Proposed Turkey Point Units 6 and 7  
Docket Nos. 52-040 and 52-041  
FPL Revised Response to NRC RAI No. 02.05.02-3 (eRAI 5896)  
L-2014-282 Attachment 2 Enclosure A Page 1 of 3

**NRC RAI Letter No. PTN-RAI-LTR-037**

**SRP Section: 02.05.02 - Vibratory Ground Motion**

**NRC RAI Number: 02.05.02-4 (eRAI 5896)**

**Figure 4.** 10 Hz mean hazard curves showing sensitivity to Cuba source scenarios. Lower panel is expanded view of yellow box in upper panel.

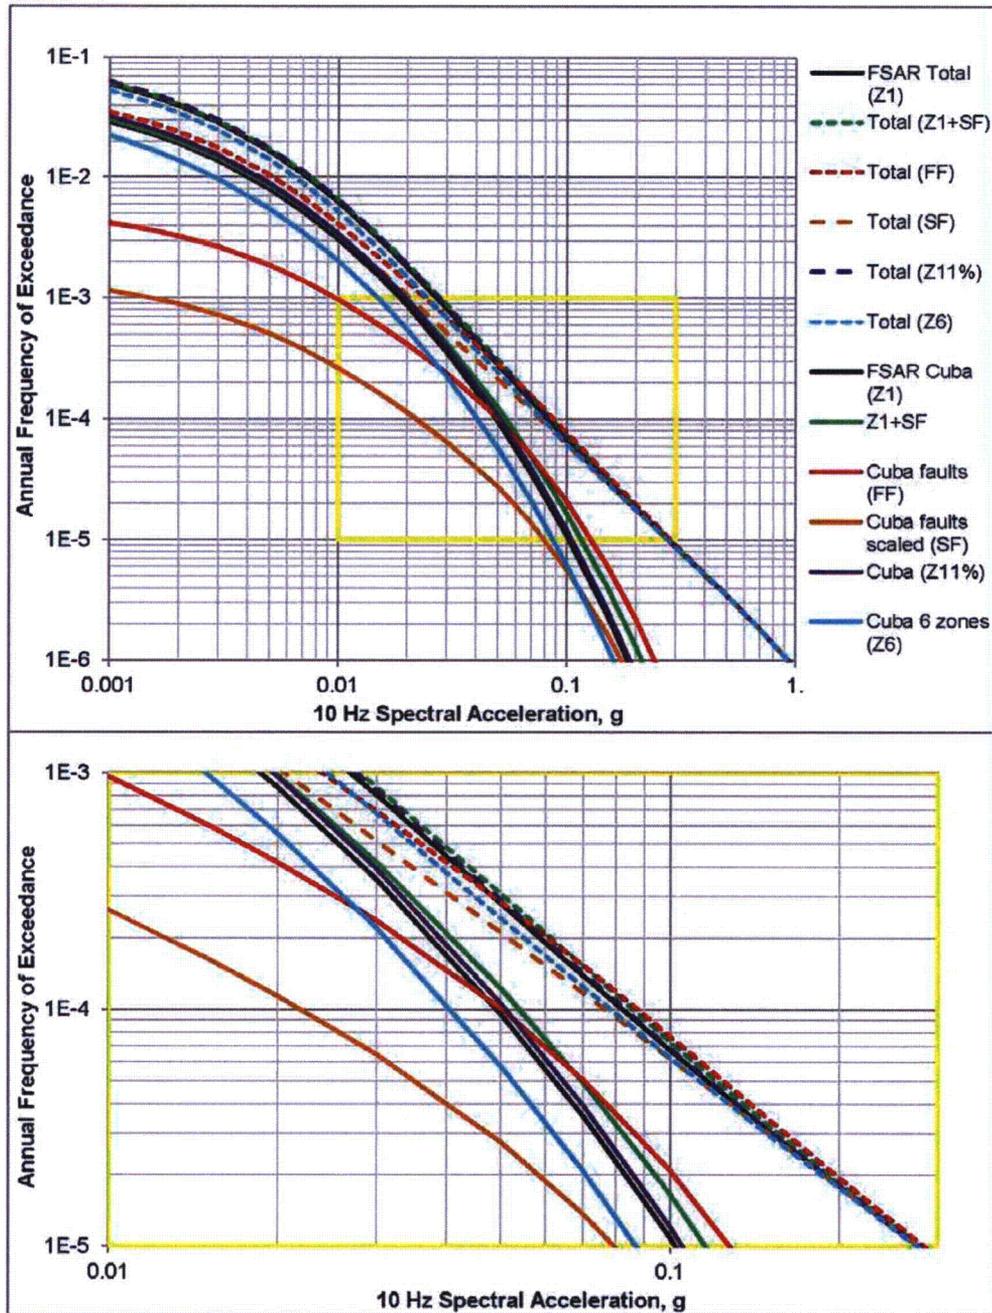
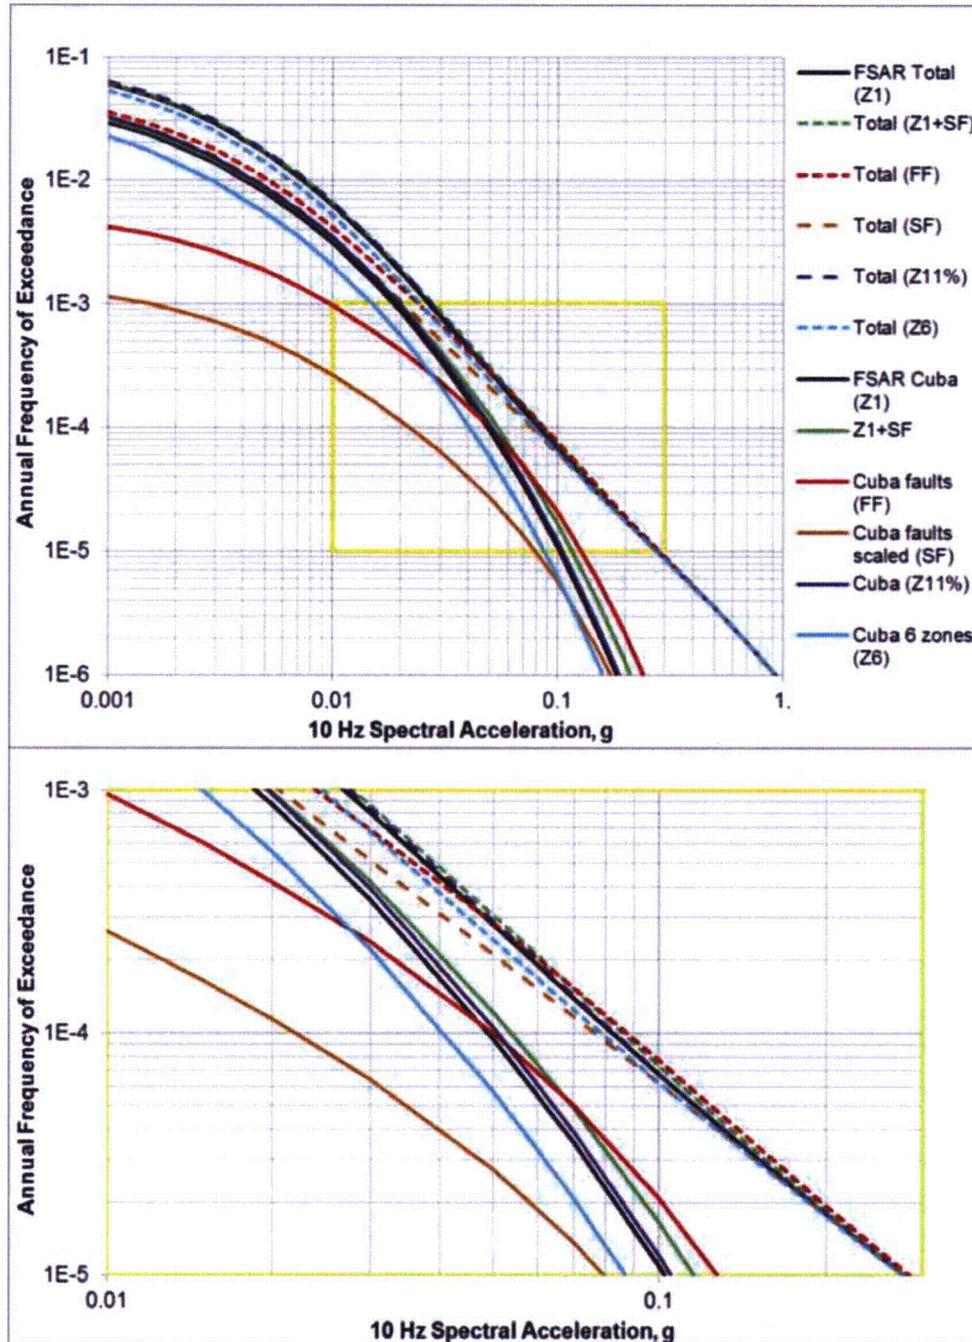
- a. Rationale for the exclusive use of an areal source rather than multiple areal sources or a combination of fault sources and areal sources. Given the uncertainties, does the use of a single areal source result in a more conservative representation of the hazard from the Cuba seismic sources?

In order to assess the impact of various Cuba sensitivity scenarios on the Turkey Point Units 6 & 7 site hazard, based on the evaluation of the hazard results presented in Figures 3 and 4, four sensitivity scenarios (Z6, Z11%, SF, and Z1+SF) were selected to represent the Cuba hazard in lieu of the Z1 base case scenario used for the original FSAR hazard total. Total hazard curves that include these four scenarios are presented in Figure 5, along with the original FSAR total hazard.

To assess the impact of various Cuba sensitivity scenarios on the Turkey Point Units 6 & 7 site hazard, based on the evaluation of the hazard results presented in Figures 2.5.2-273 and 2.5.2-274, four sensitivity scenarios (Z6, Z11%, SF, and Z1+SF) were selected to represent the Cuba hazard in lieu of the Z1 base case scenario used for the original base case hazard total. Total hazard curves that include these four scenarios are presented in Figure 2.5.2-275, along with the original total hazard.
